C7/JGS COMMENTS  
10.29.18

PROJECT: One Dalton

DESCRIPTION: Granite Bollard Anchorage

DWG NO. M288

▶ STAINLESS STEEL  
Granite Bollard Anchorage  
3D View

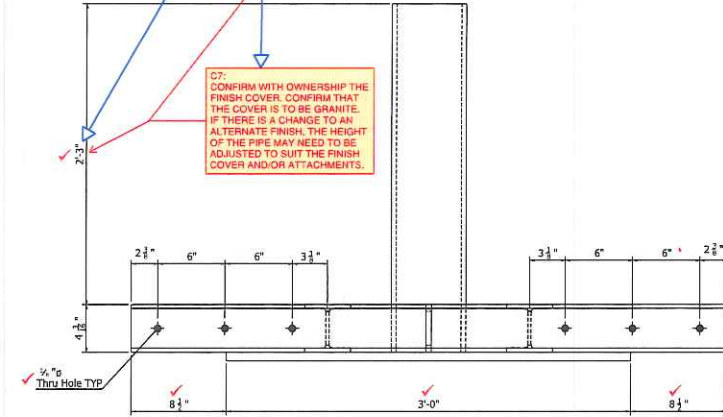
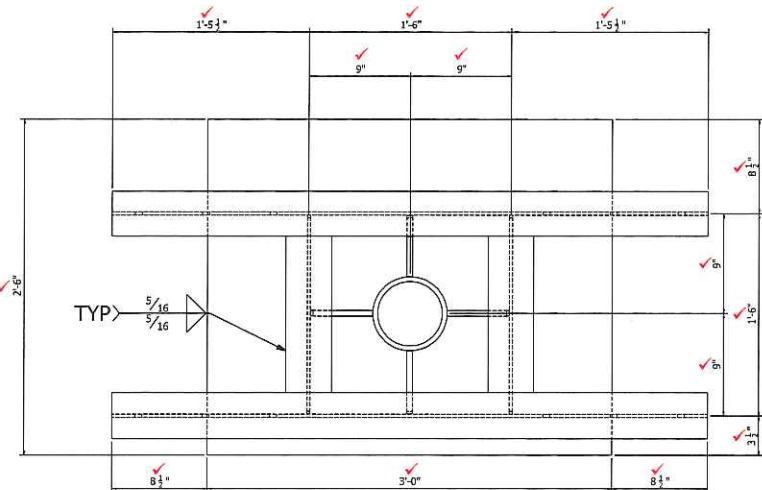
C7: CONFIRM WITH OWNERSHIP THE FINISH COVER. CONFIRM THAT THE COVER IS TO BE GRANITE. IF THERE IS A CHANGE TO AN ALTERNATE FINISH, THE HEIGHT OF THE PIPE MAY NEED TO BE ADJUSTED TO SUIT THE FINISH COVER AND/OR ATTACHMENTS.
